**City of Poughkeepsie
Historic District and Landmarks Preservation Commission
Meeting Agenda**

**RE: Pelton Mount Carmel
36 North Clover Street
Revised Submission**

Re: Project: Pelton Mount Carmel
36 North Clover Street
Re: Revised design of proposed development for HDLPC Approval

PRELIMINARY
ELEVATIONS -
PELTON MANOR

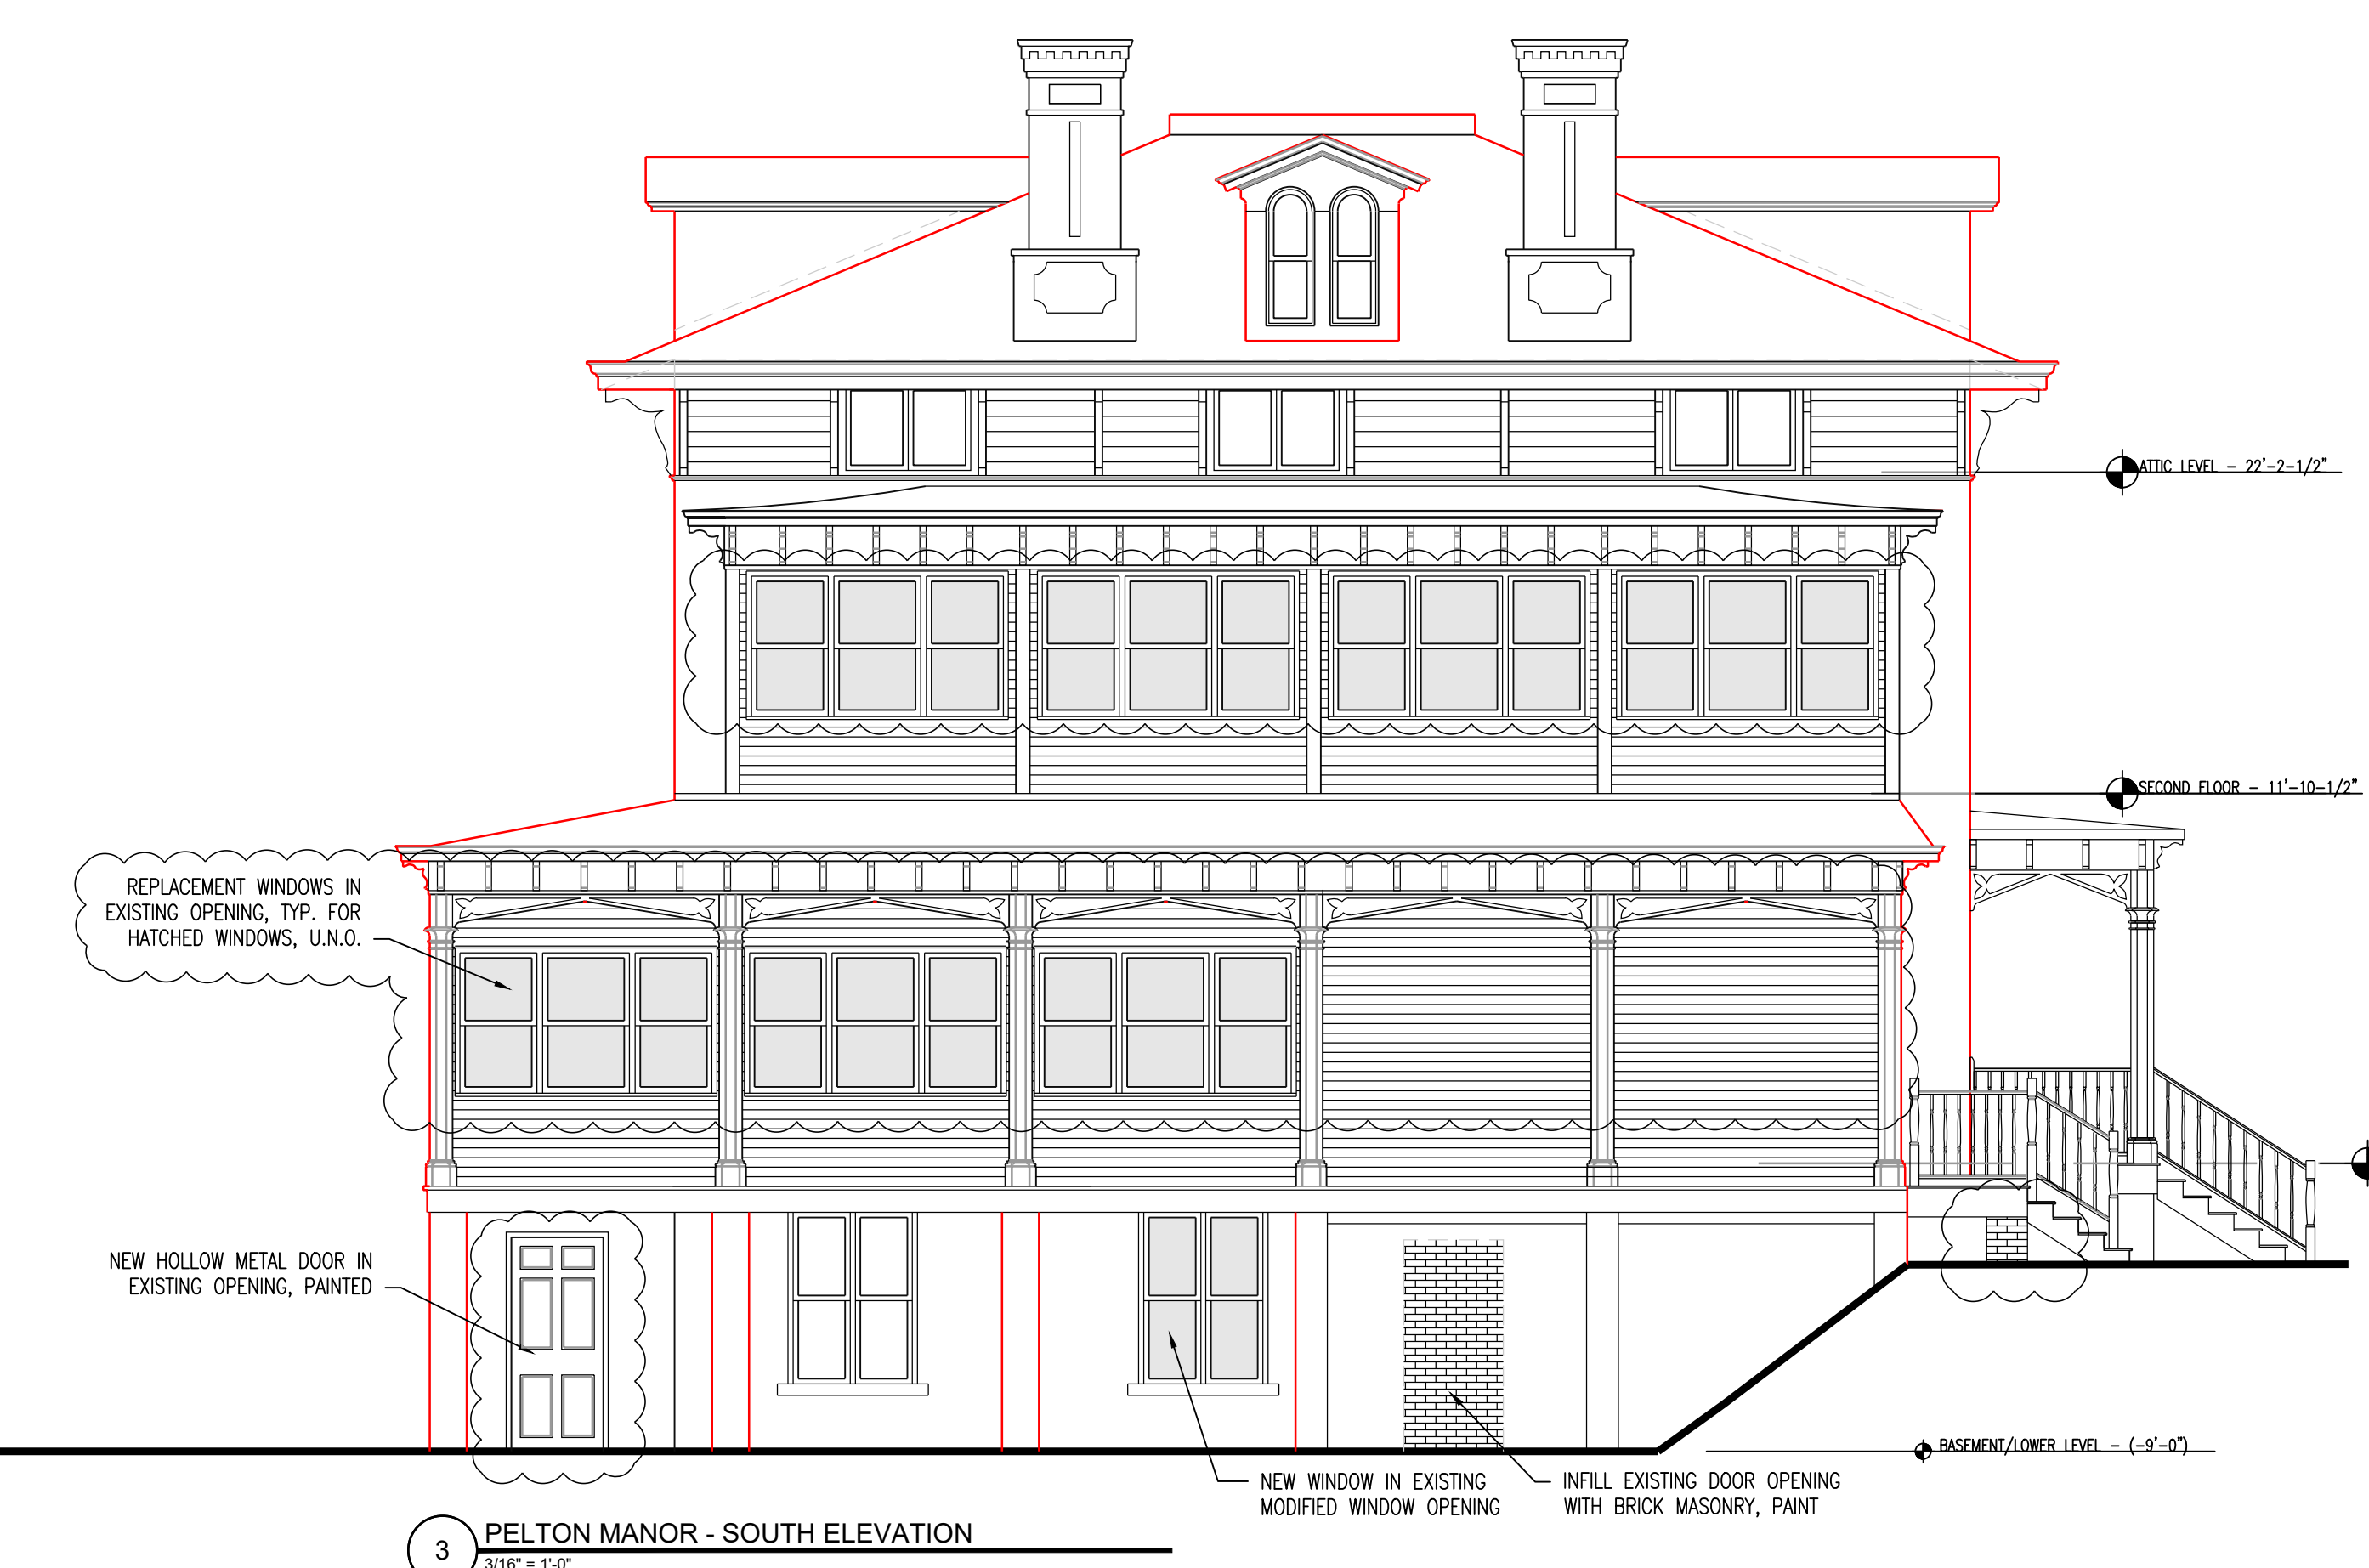
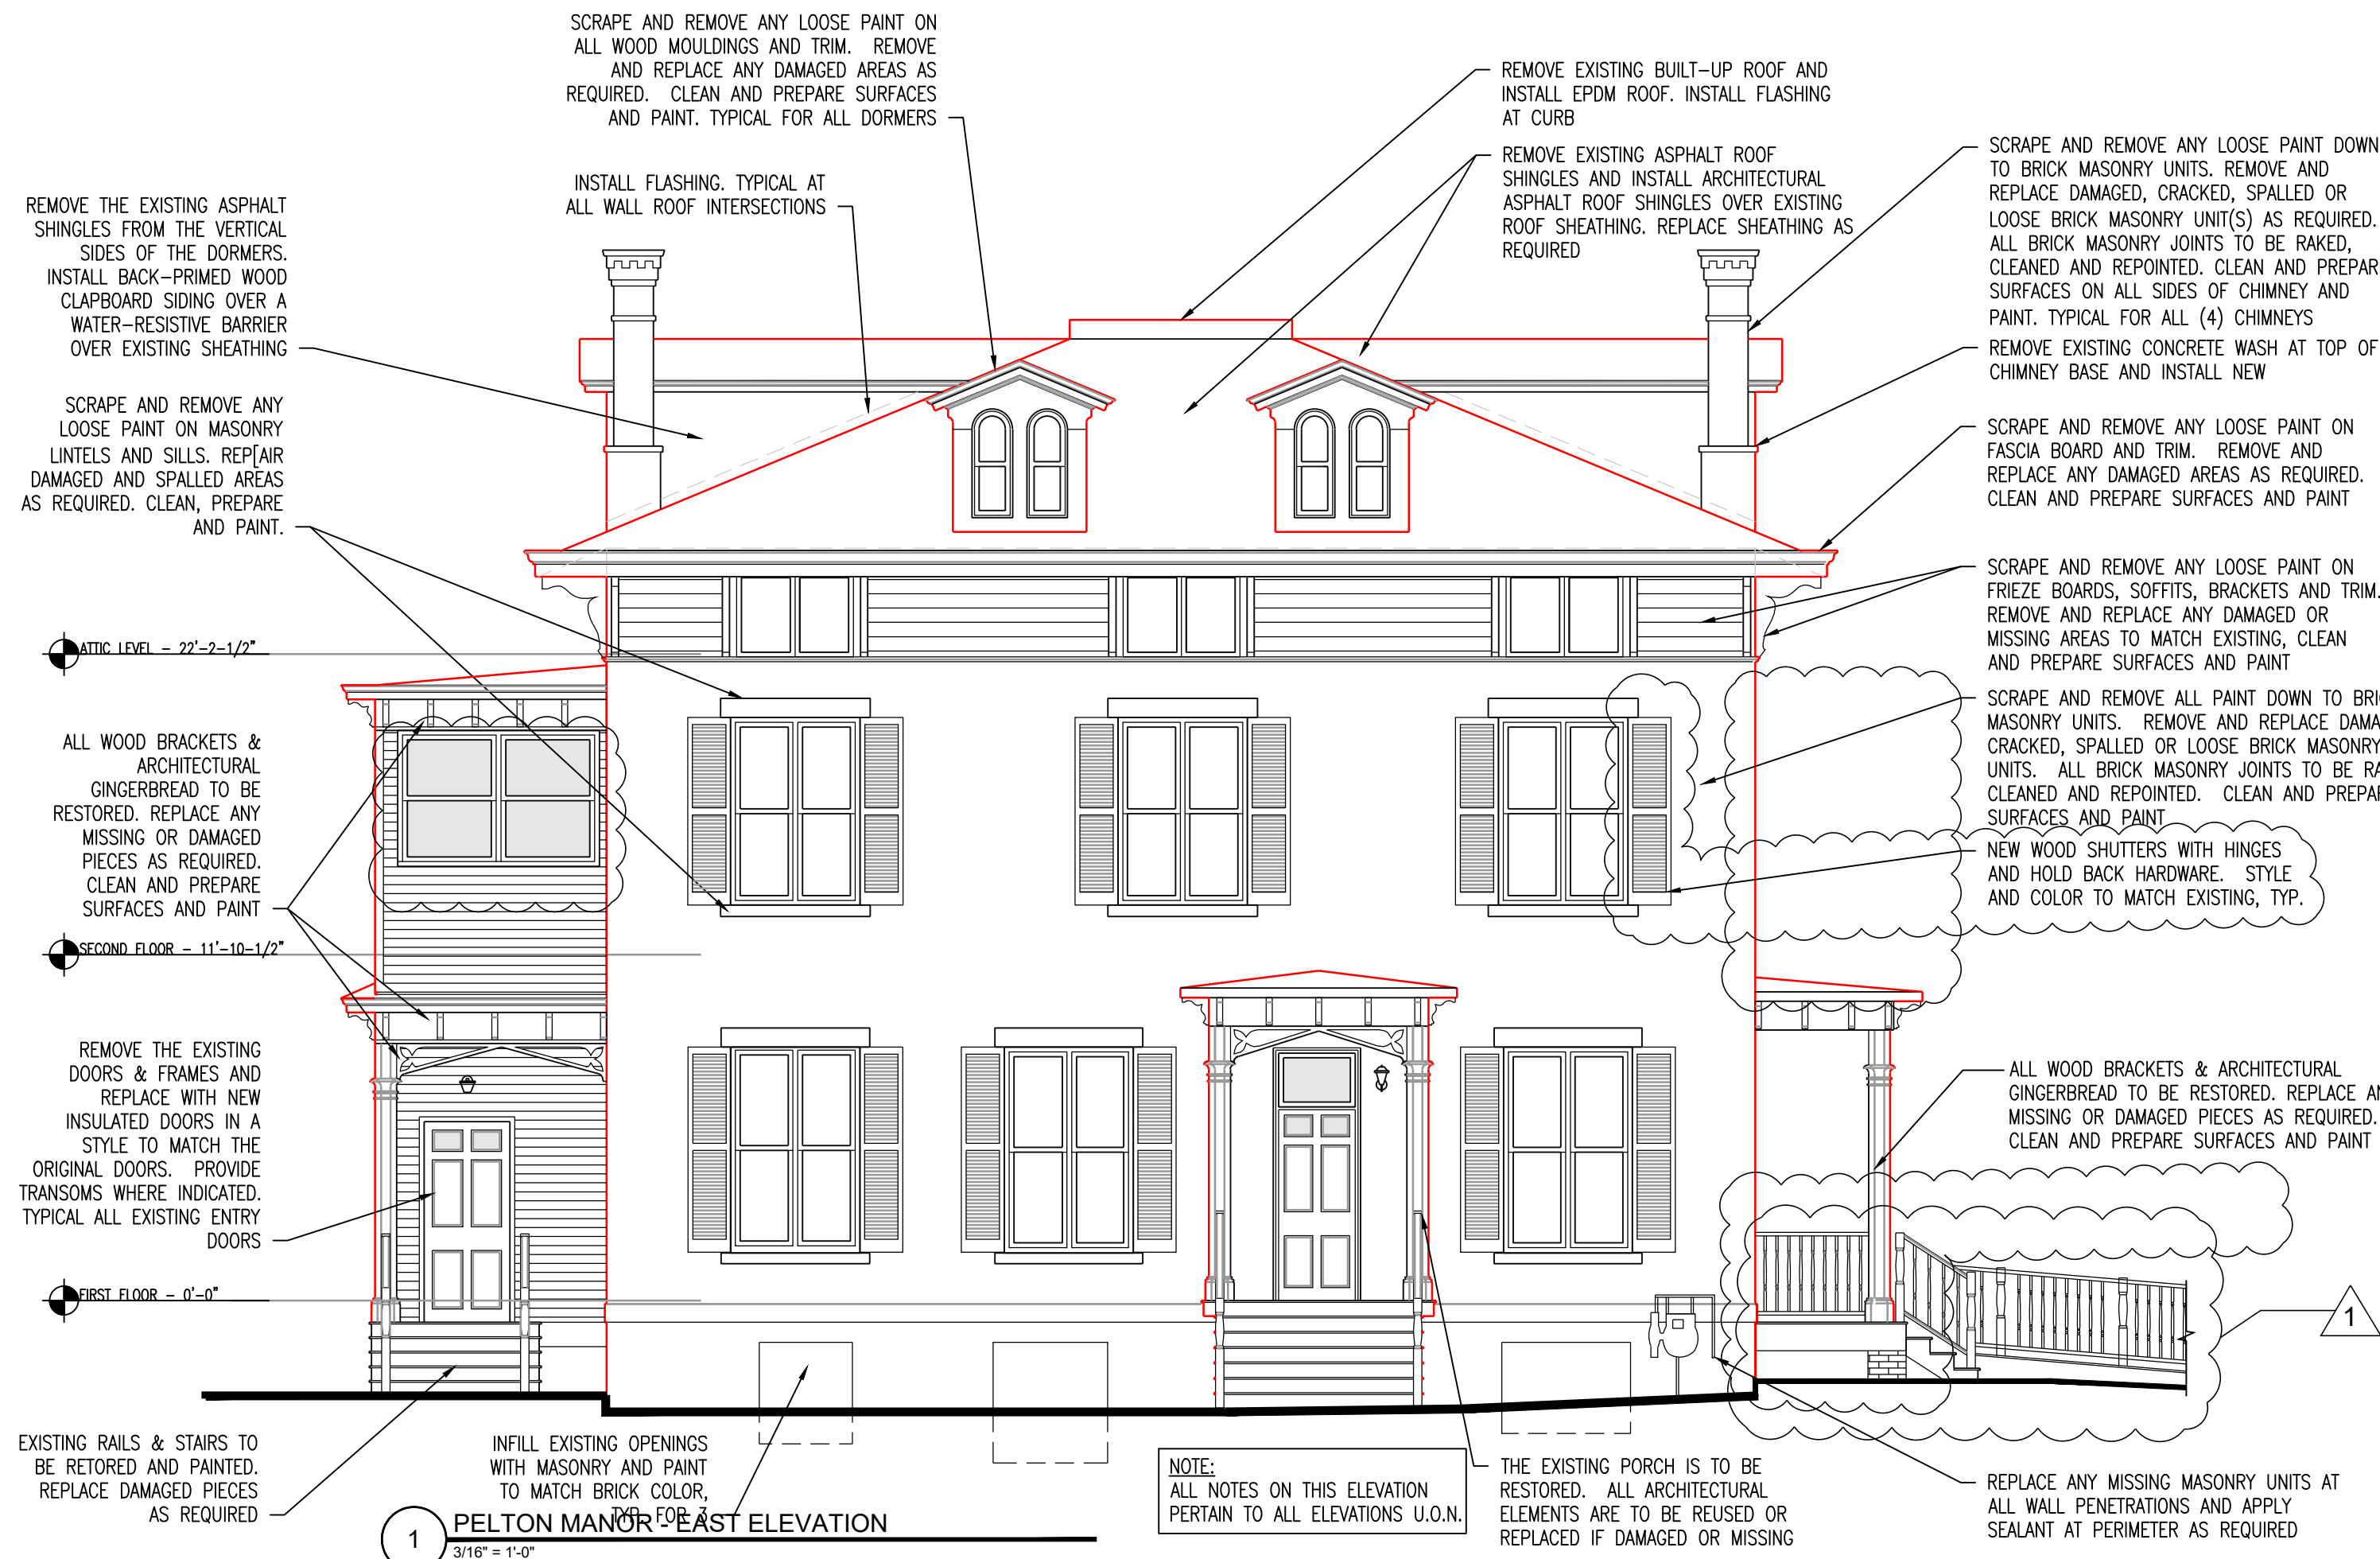
Sheet PZ-08 – Preliminary Elevations – Pelton Manor:

1. Elevations 1, 2 & 4 have been modified to include the elevations of the proposed handicap ramp being proposed for the north side of the Pelton Manor.
